Throughout the summer the Town Hall Project has progressed with the appointed architect, additional consultants and staff. On 22nd July 2021 Cllr Lyn Walters stepped down from the Town Hall Working Group. Two Working Group meetings have also been held. Please see details below.

Working Group Meeting Friday 23rd July 2021

Members reviewed a Proposed Site Plan and Ground Floor Plan produced by the architect and discussed the following:

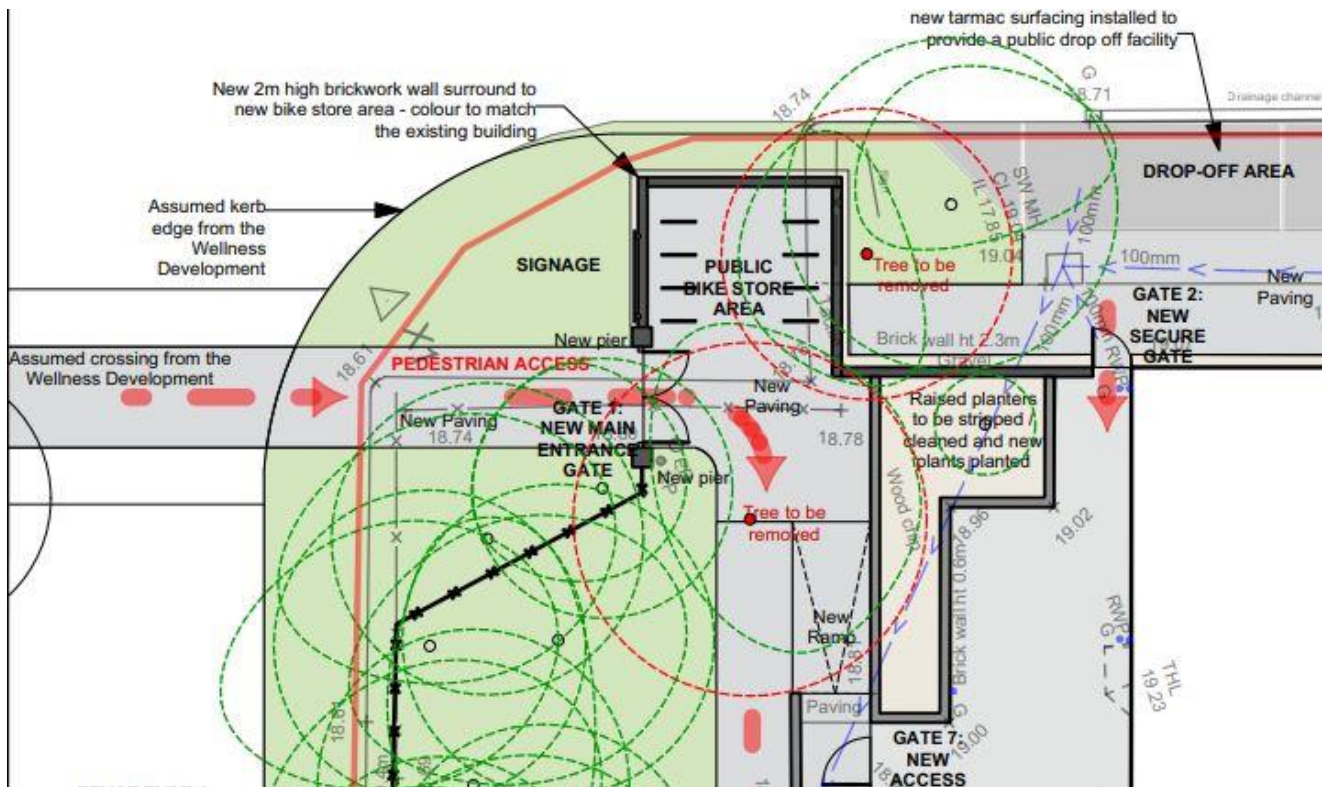
At the Southern entrance which is directly off the crossing from the Wellness Village, the architect had proposed a full height brickwork enclosure to connect to the existing brick wall to provide a solid surface to place external signage on the outer face of the wall and provide an enclosure for a bike store for the public. The brick wall would connect to brick piers to form the opening for the bike store and link in with the archway, gate and railings proposal.

- Members of the Working Group discussed this proposal in detail and did not support pursuing this option. The architect was asked to remove the bike store from the plans. Members considered that bike storage could be provided at the northern end of the building by relocating the existing metal cycle uprights to the grassed area.
- Members considered the security implications of retaining Gate 2 and agreed that this gate should not be retained. The architect was advised that Gate 2 should be blocked up and was asked to reflect this in the plans.
- Members agreed that the height of the wall alongside Gate 2 should be reduced to the height of the raised bed the others side of the wall and suggest topping the wall with a coping stone to which black bow top metal railings are attached.

- The bricks removed from the wall mentioned above should then be used to block up Gate 2 so that the brick work is the same colour.
- Members considered the proposed drop off area and thought that it was too far into the site. The architect was asked to move the drop off area closer to the gate, in the current position of the bike store on the plans.

- The pedestrian access shown on the Proposed Site Plan was a straight line from the pedestrian crossing and different to the curved Southern Access previously agreed by Council and submitted to BCBC for the Permitted Development application. Members wished to pursue the original curved path, leading to the archway and gate. The architect was asked to revise the plans to include a curved path which passes the raised beds and leads down to a new ramp access to the main entrance.

- Members noted that the railings alongside the southern part of the site were set back from the red boundary line and queried if there was a reason for this. Members expressed concern that this creates a 'no mans land' between the shared access road and the new railings which will need to be maintained. There is a low wall along the bottom end of this area (near Sunnyside lane) and Members asked if it is possible for the railings to be mounted on top of the wall at this section and taken in a straight line, right to the edge of the boundary up towards the pedestrian access. This was fed back to the architect.

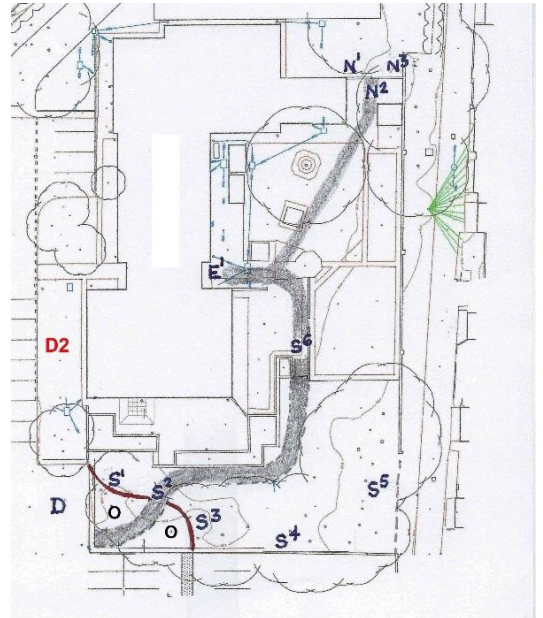
The architect proposed a suggestion for the fencing treatment along the South boundary of the property which can be seen from the Wellness Village. He suggested an elegant conservation style approach of black wrought iron bow top fences to a height of 2m approx. and to introduce number of laser cut plaques between the railings to help break the elevation and to illustrate the Town Council history etc. They could be photographs which a company can scan and then laser cut the black sheets from the computer and can be installed in bespoke fence panels.

- Members of the Working Group considered laser cut panels for the boundary railings however it was noted that the Council have experience with laser panels on another project in the Town Centre and expressed concern about cost, health & safety concerns (from children getting fingers trapped) and timescales to incorporate these. For these reasons it was decided that the project at the Town Hall should progress with standard bow topped railings that should be simple and economical.
- Members considered wrought/fabricated iron railings versus cast iron (conservation) railings. Bob Burns advised that he had sought costs from a local supplier and was told that the cast iron railings are 3-5 times more expensive than round or square fabricated railings.

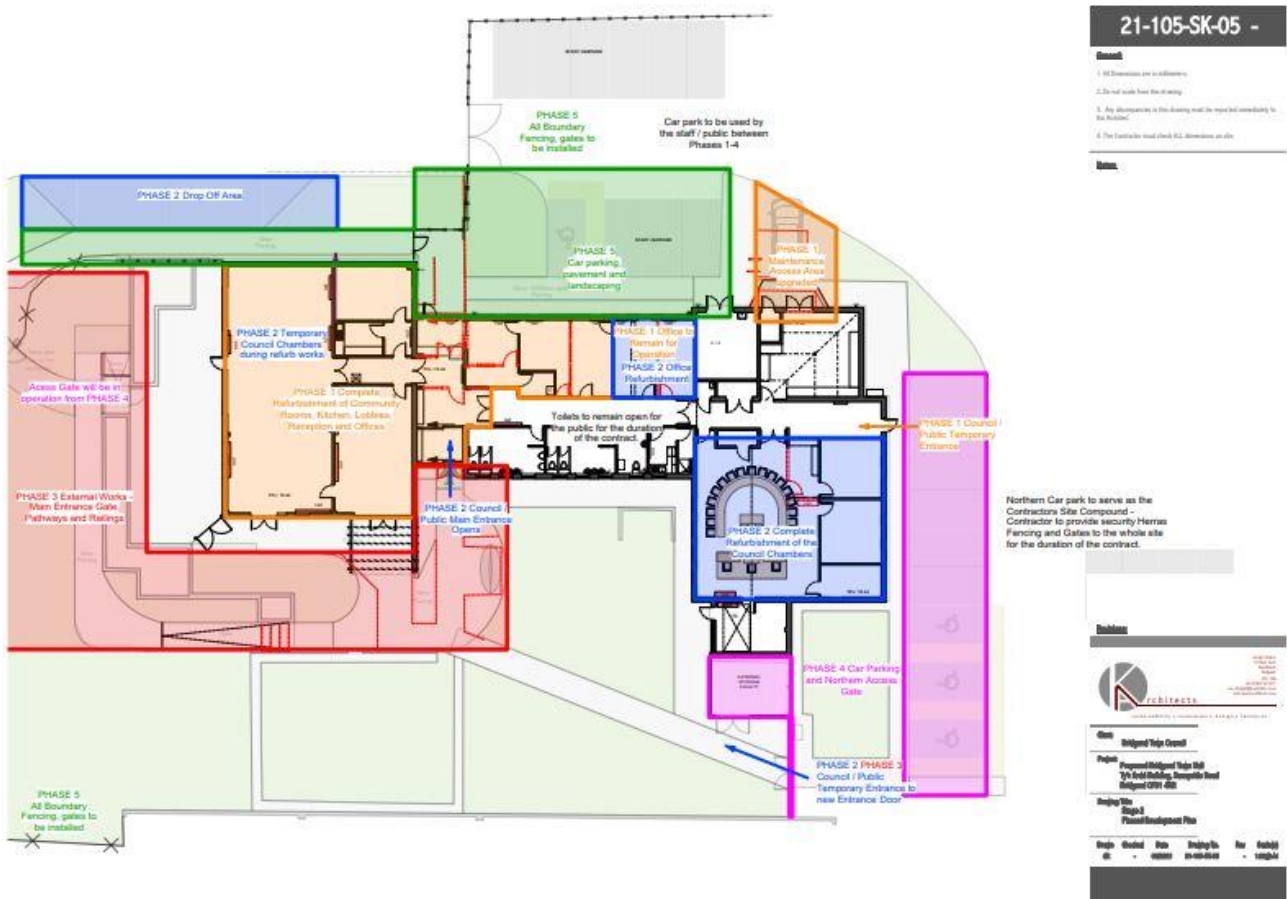
- a) New Memorial Gate – This is permitted development under Part 12 of the GPDO 1995 as it is less than 4m, is set into the site, is not within the setting of a listed building, is on your land and a Town Council is classed as a Local Authority under the regs.

- b) New railings – The majority of the railings can go up to 2m in height under pd rights (Part 2A) (as they are set back off the highway) apart from the element directly fronting the adjacent lane to the east of the building. As this is necessary for security, and to avoid having to submit an application for a 1.4m high railing at this point, I would suggest setting the railing back into the site at this point by around a metre as the railings will still be see-through and should not cause any visual impairment to users of the lane.

- c) New graded footway from private road drop-off to Town Hall floor level – this element does not require planning permission as the internal road will not be a classified highway and as long as there is no significant raising or lowering of the land as a form of engineering operation.

- d) New landscaping adjacent to the footway – this does not require planning permission as it is not classed as development and is supported.

- a) The memorial gate design is below the 4m height. It has been designed to be as low as it can go to help keep the cost down. The height of the gate can be increased, but so will the cost.
- b) Perimeter / boundary fence has been designed at a 2m height as this is the minimum height for a security fence. The planners comment suggest that this fence is to be set 1m inside from the kerb edges – apart from the East side.
- c) There is only a 150 – 200mm level difference to this area and will not be significant enough to be classed as an engineering operation.
- d) A decision will need to be made if this footpath is to be one of the following:
 - a) Permeable resin bonded pathway, b) Tarmac pathway or c) Paving slabs pathway

Image 1: Proposed Quotation Plan

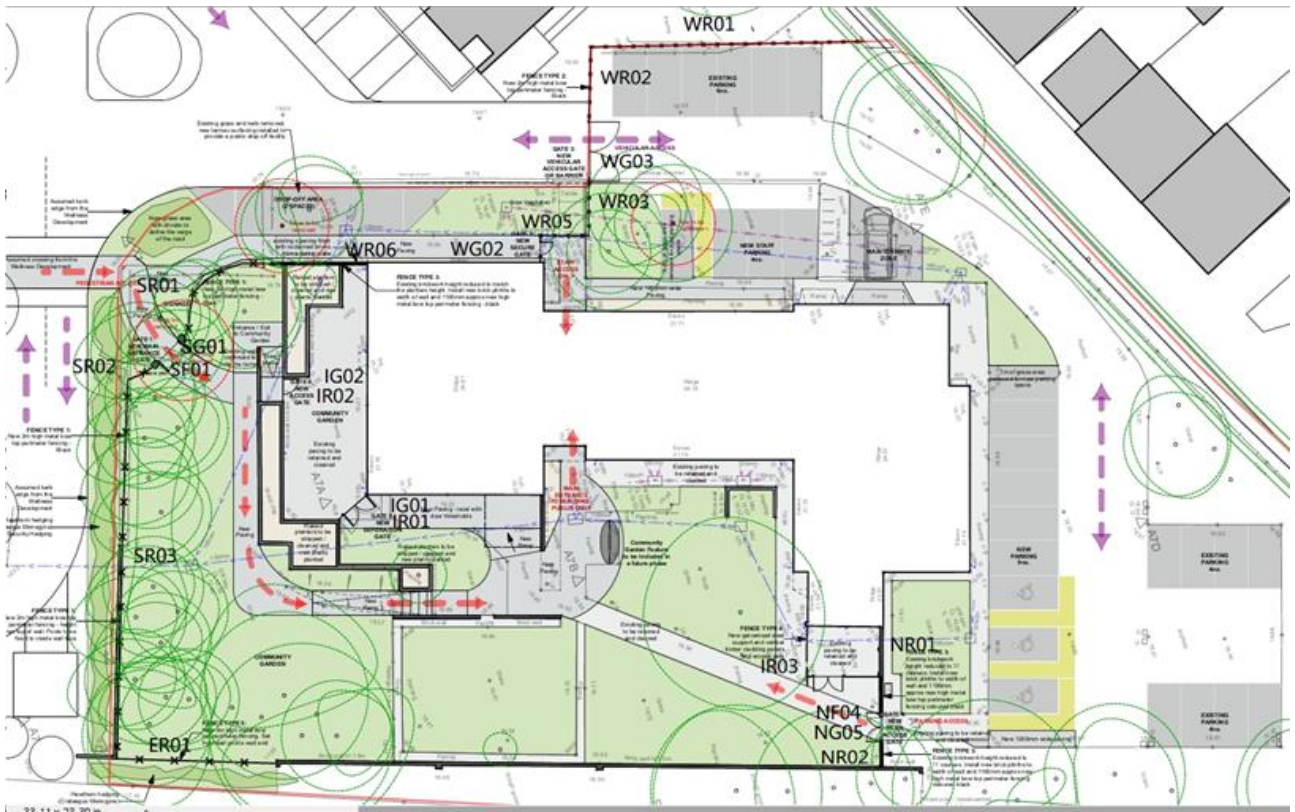
The draft brief introduces itemised sections (also refer to Image 1: Proposed Quotation Plan below) of Railings and Gates to provide more detailed analysis of each quotation and flexibility to the Town Council as to need.

The Internal Railings and Gates should be evaluated as to whether they are really necessary.
